JOINT ARCHITECTURAL BOARD/PLAN COMMISSION AGENDA
MONDAY, APRIL 18, 2016
7:00 PM
BOARD ROOM
MUNICIPAL BUILDING, 210 COTTONWOOD AVE.

MEMORANDUM

TO: Architectural Board and Plan Commission
FROM: David E. Cox, Village Administrator
DATE: April 15, 2016
SUBJECT: Agenda Information – April 18, 2016

RE: Village of Hartland
Guthrie & Frey - Building - Plan Review Letter

SHEET TITLE
ARCHITECTURAL SITE PLAN

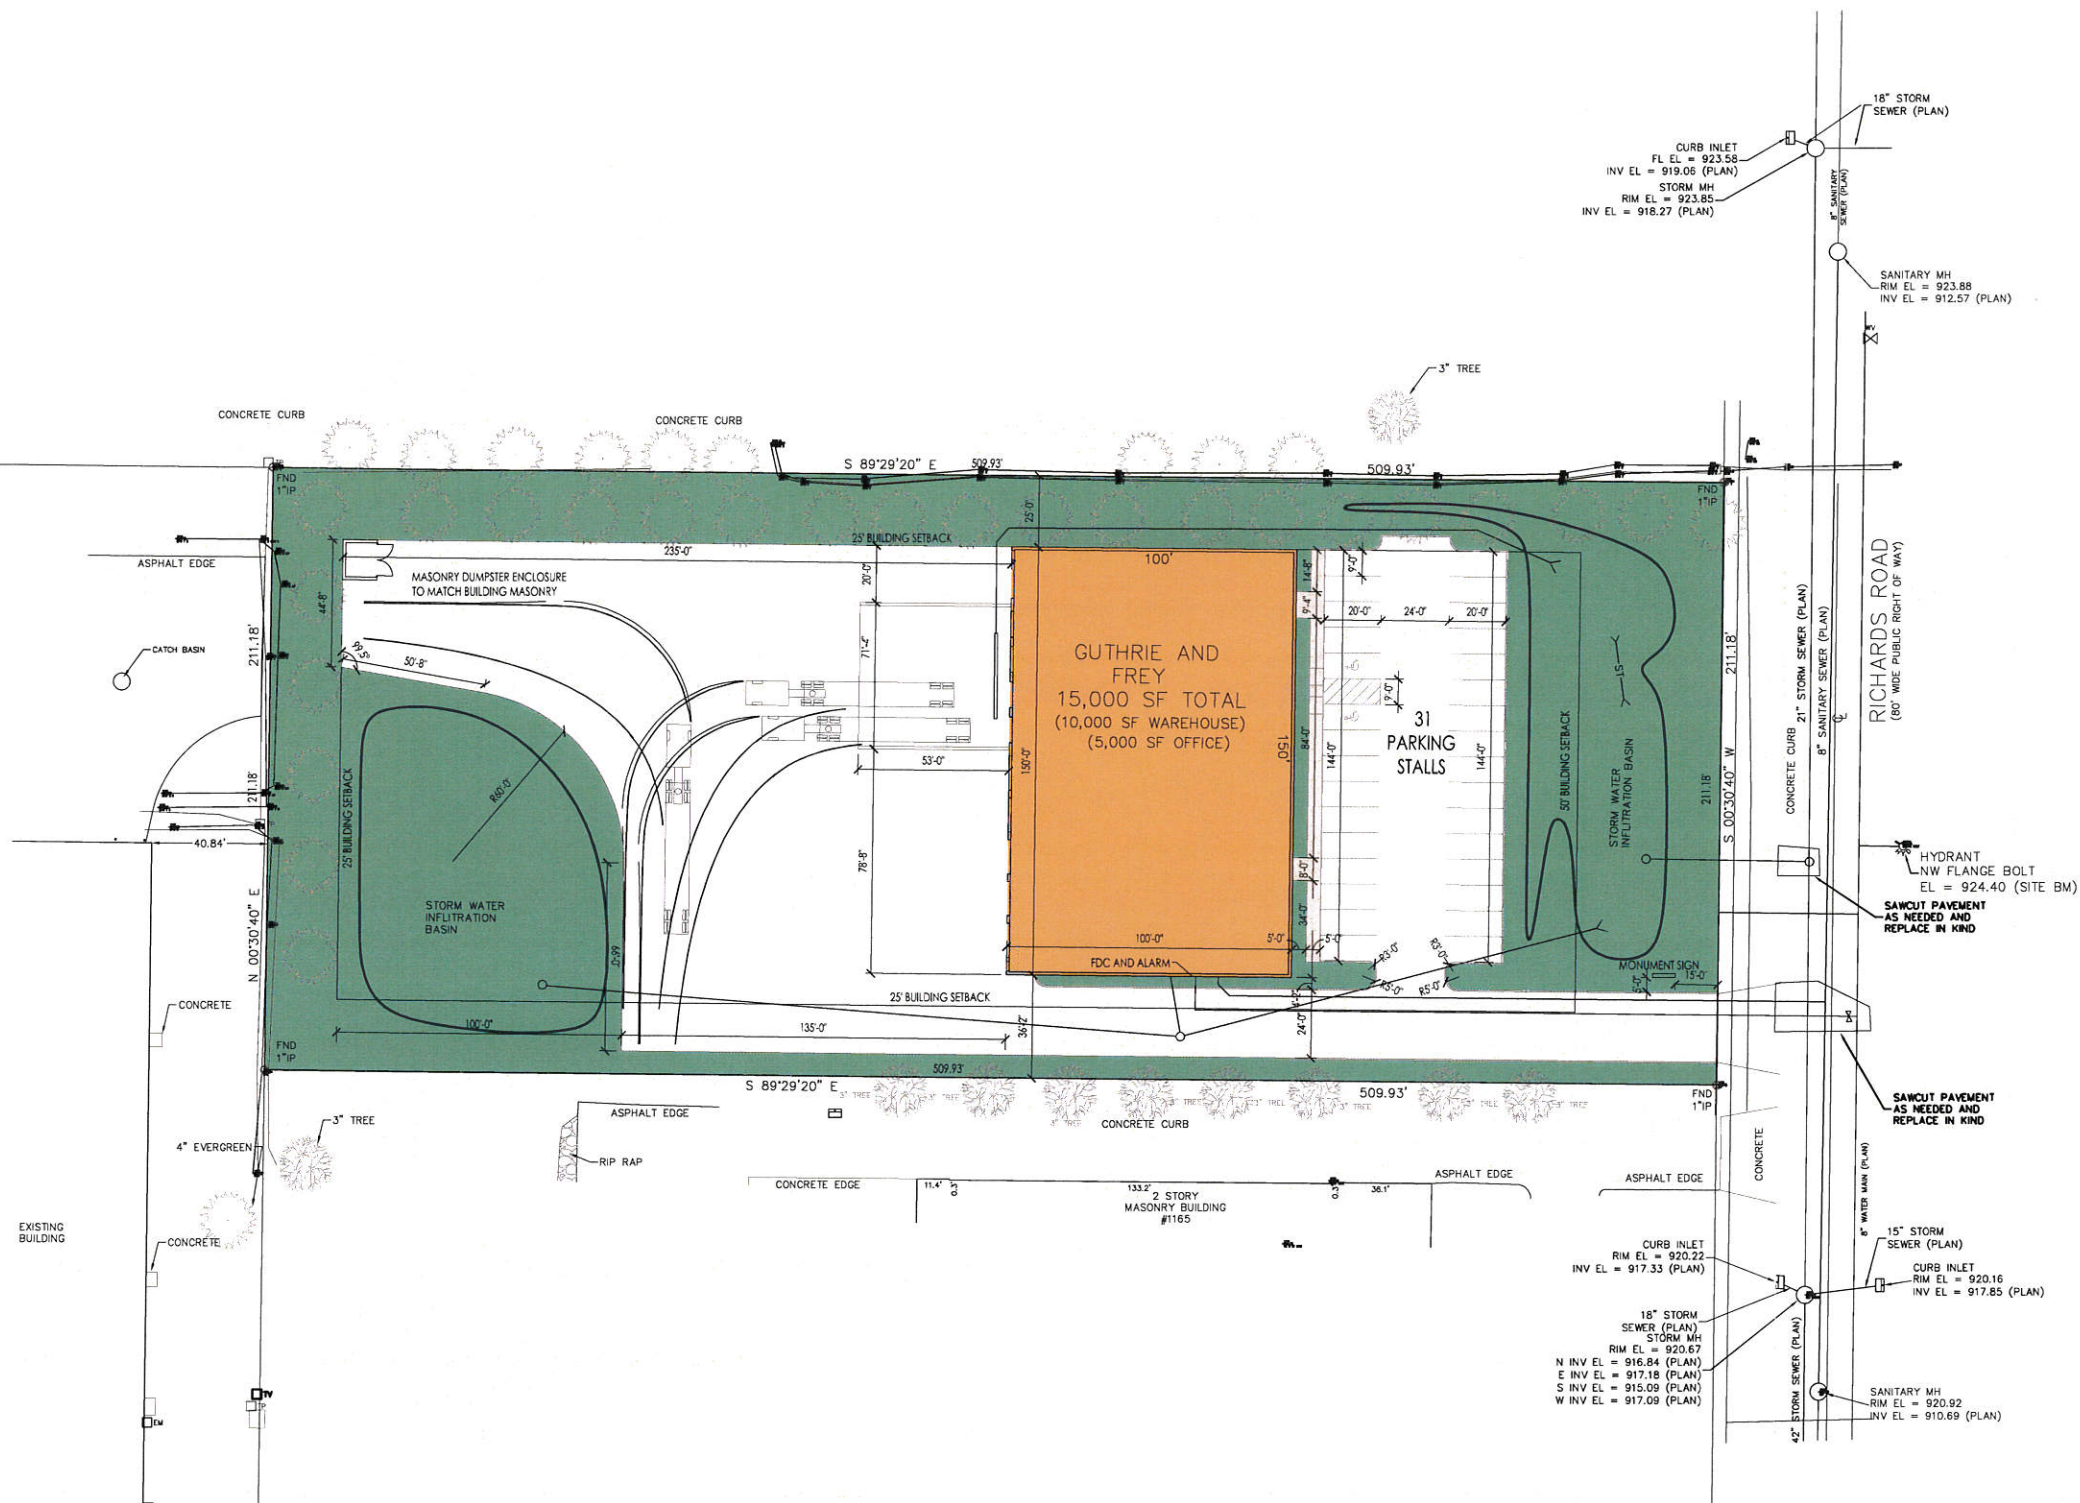
1. Provide a site coverage and parking calculation table.
2. Review the suitability of utilizing the existing sanitary and water services that are stubbed to the property to limit excavation in Richards Road.

SITE EROSION CONTROL PLAN

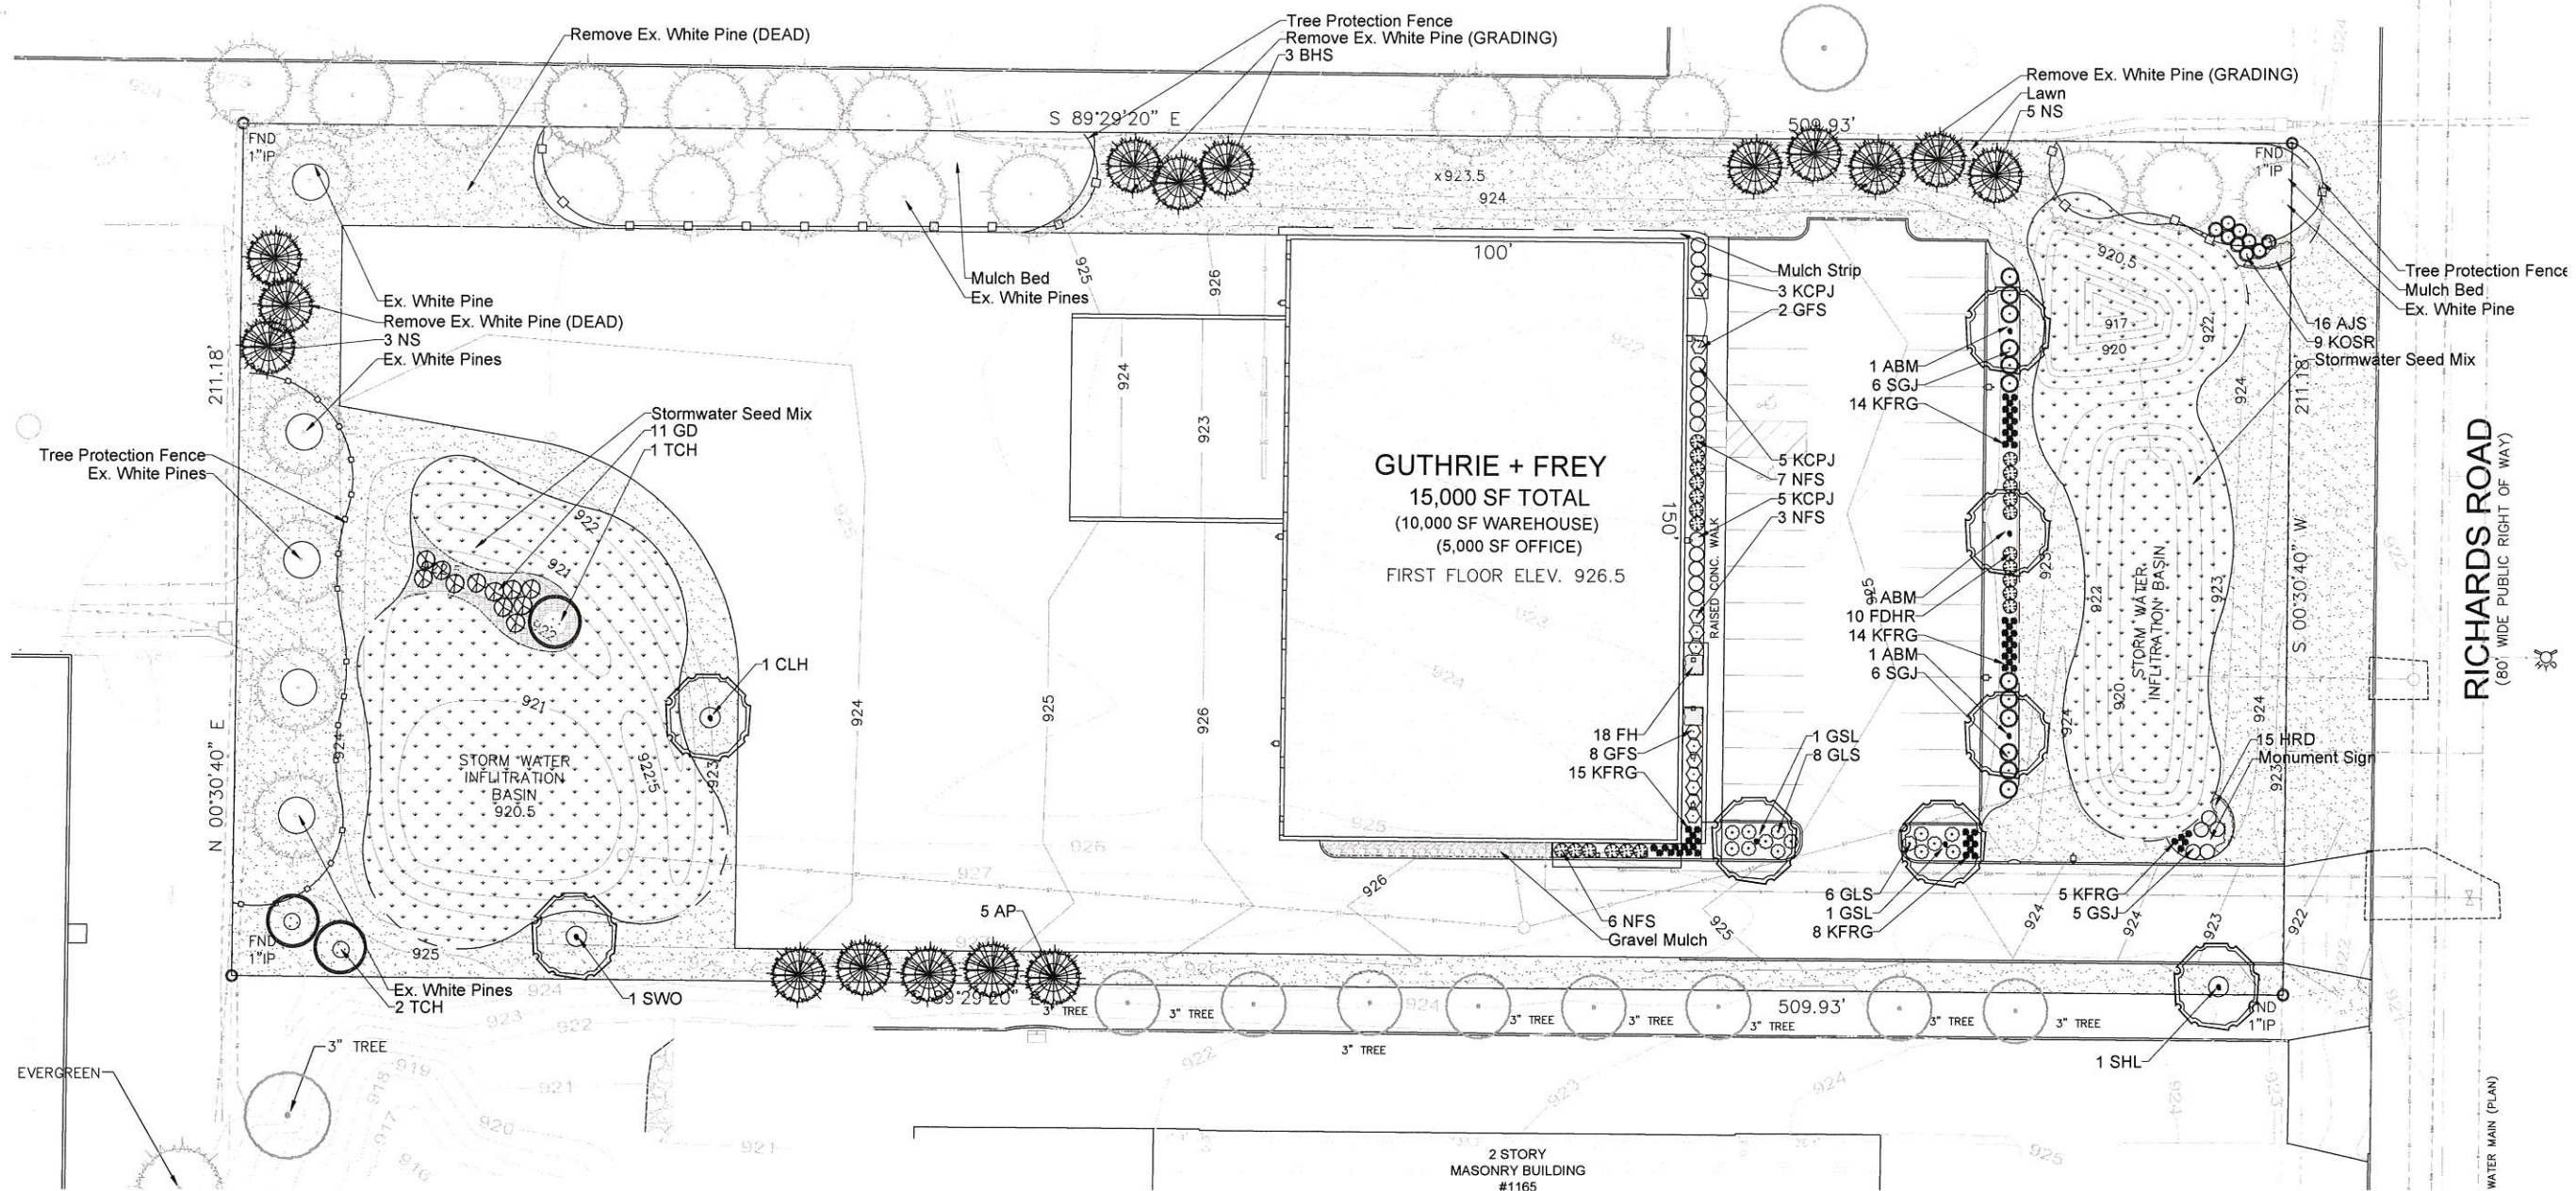
1. Utilize erosion mat for all pond and channel slopes on site.
2. Consider updating the sequence to have all disturbed areas stabilized prior to performing the final 2-foot cut in the infiltration areas and installing the engineered fill.
3. Provide Type D inlet protection for first set of downstream inlets in Village roadway.
